Addendum No. 1
Rock River Water Reclamation District
Plant Roadway Improvements 2020
Capital Project No. 2106

This Addendum No. 1, dated August 13, 2020, for the above referenced project, supersedes all contrary and conflicting information in the specifications and contract documents, which are hereby supplemented or revised as follows:

PLANT ROADWAY IMPROVEMENTS 2020 CAPITAL PROJECT #2106

TYPICAL SECTIONS ALIGNMENT F -2

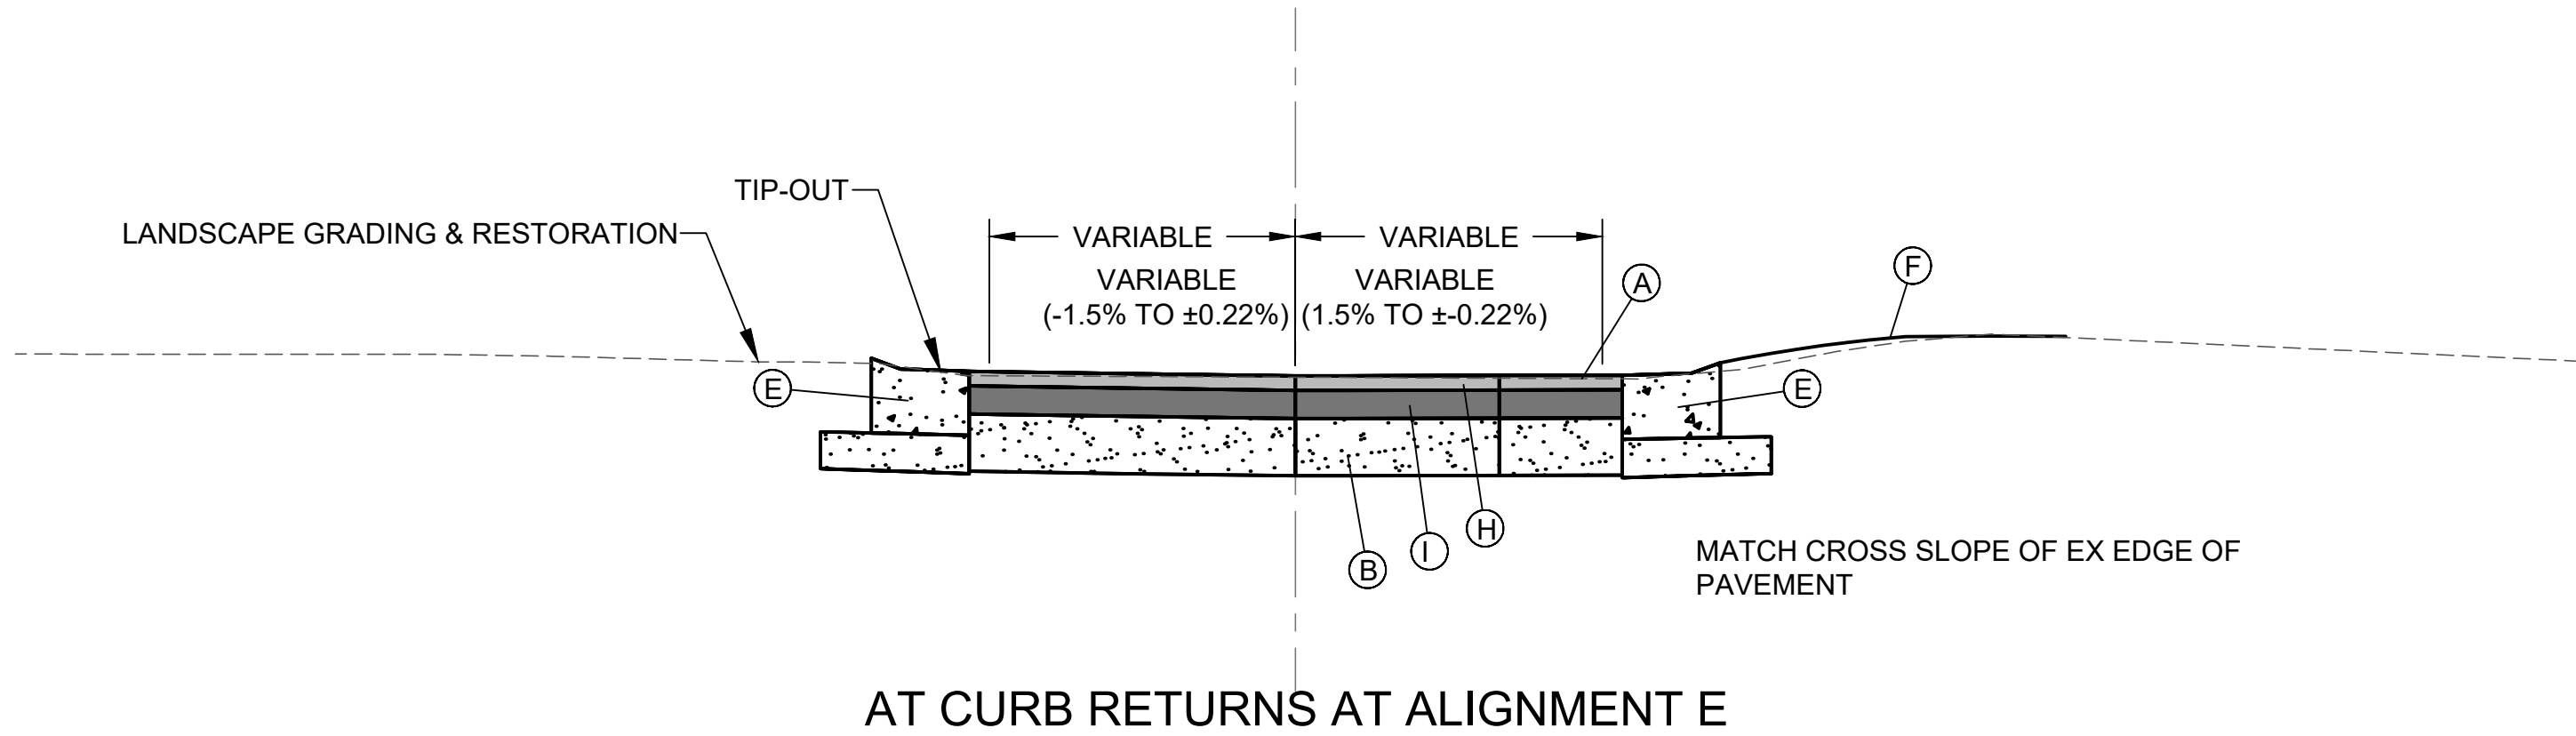
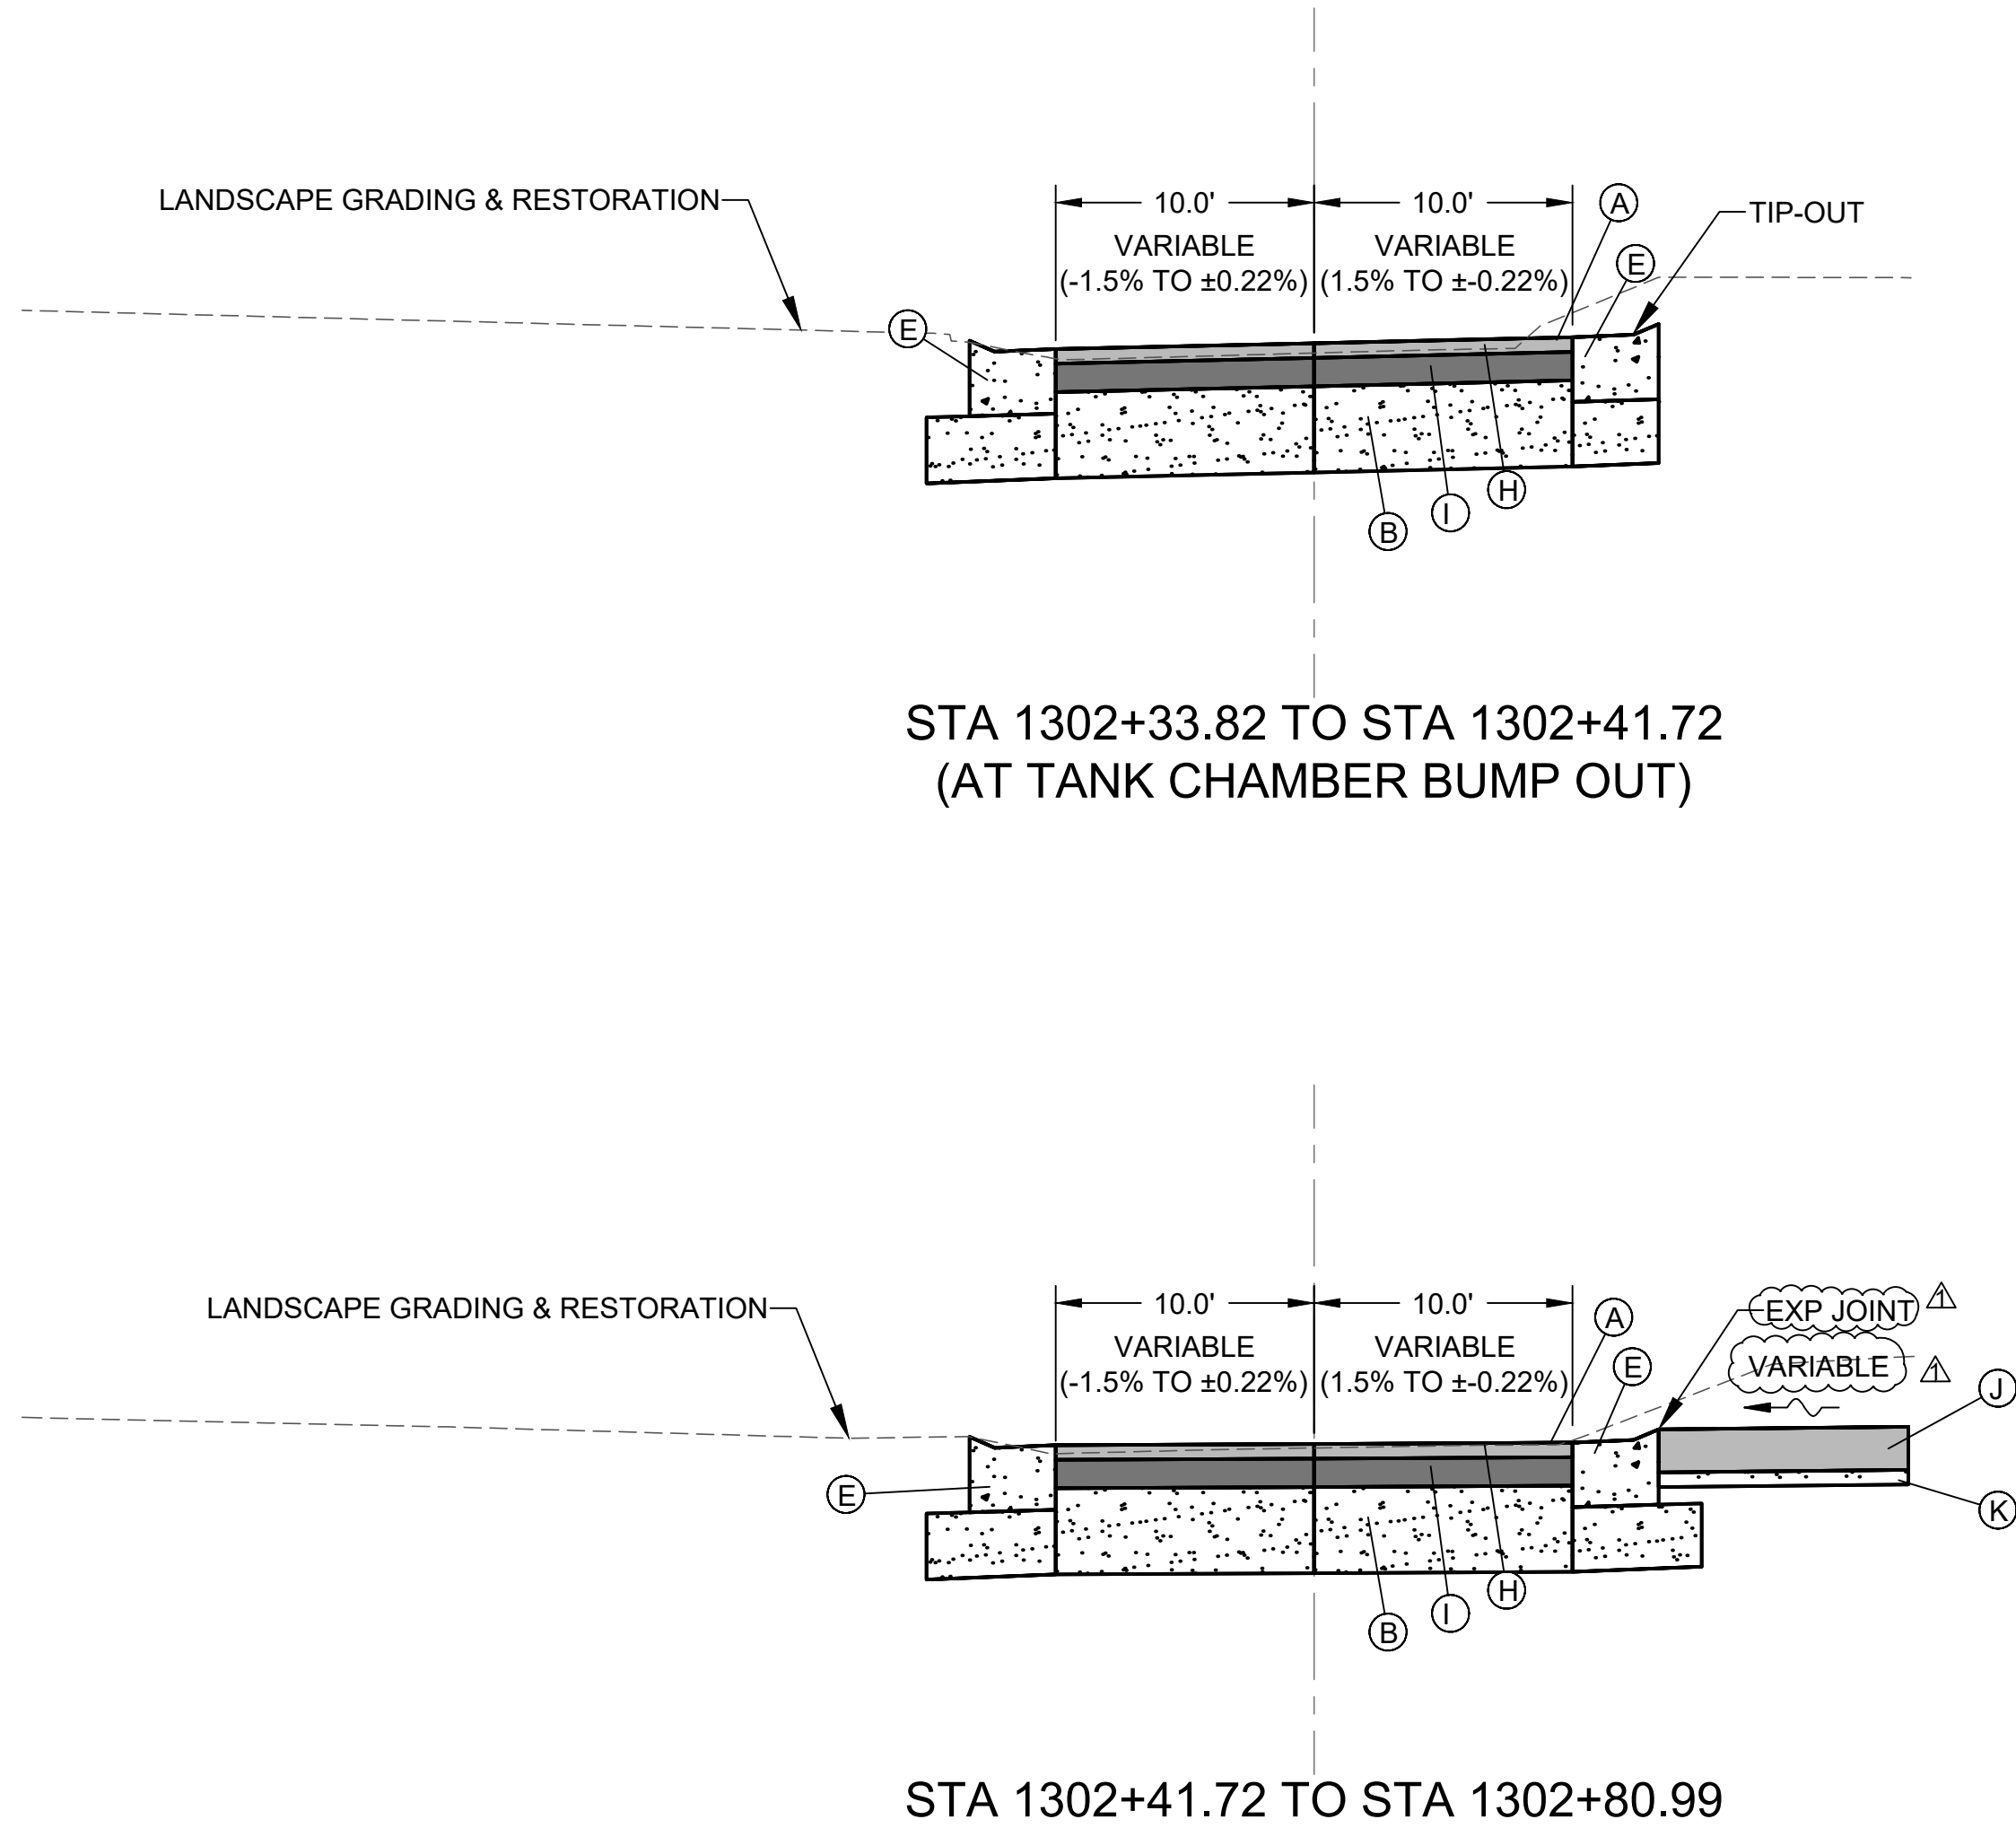
1. Typical Sections have been updated to reflect the addition of expansion joint and to note that the proposed PORTLAND CEMENT CONCRETE SIDEWALK, 6" will have a variable slope.

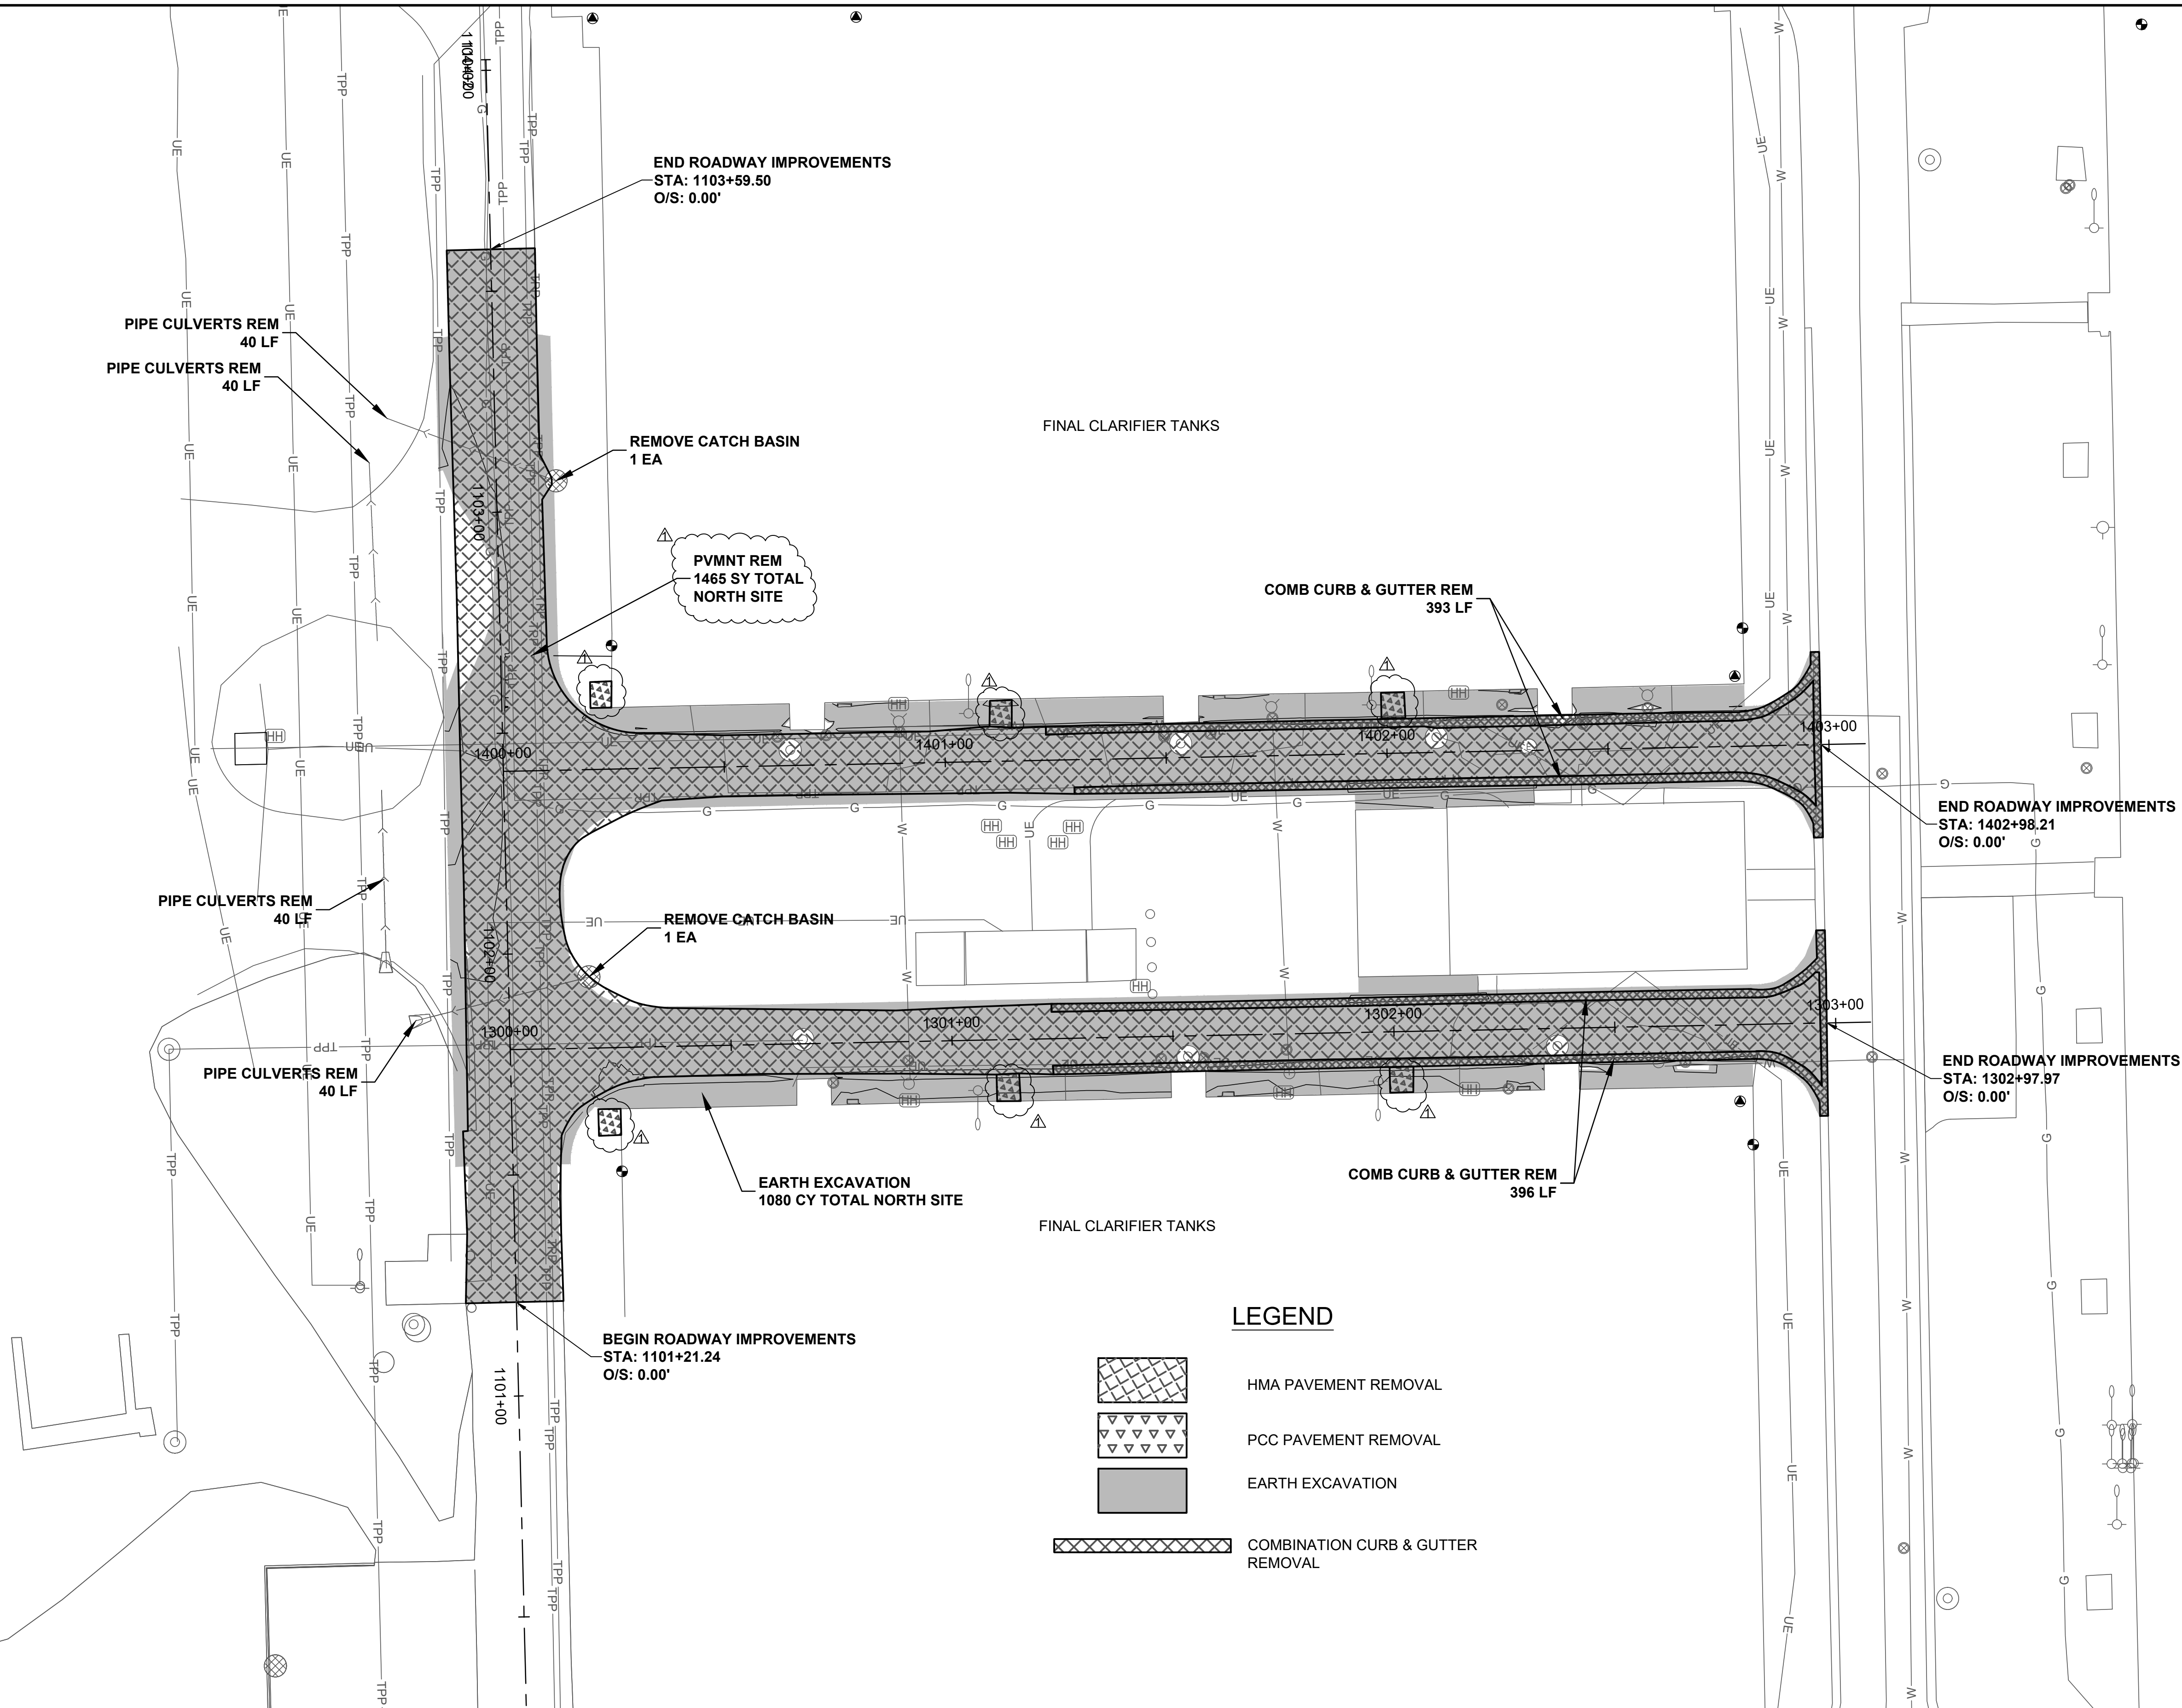
1. Removals plan has been updated to reflect additional CLEARING & GRUBBING / TREE REMOVAL area.
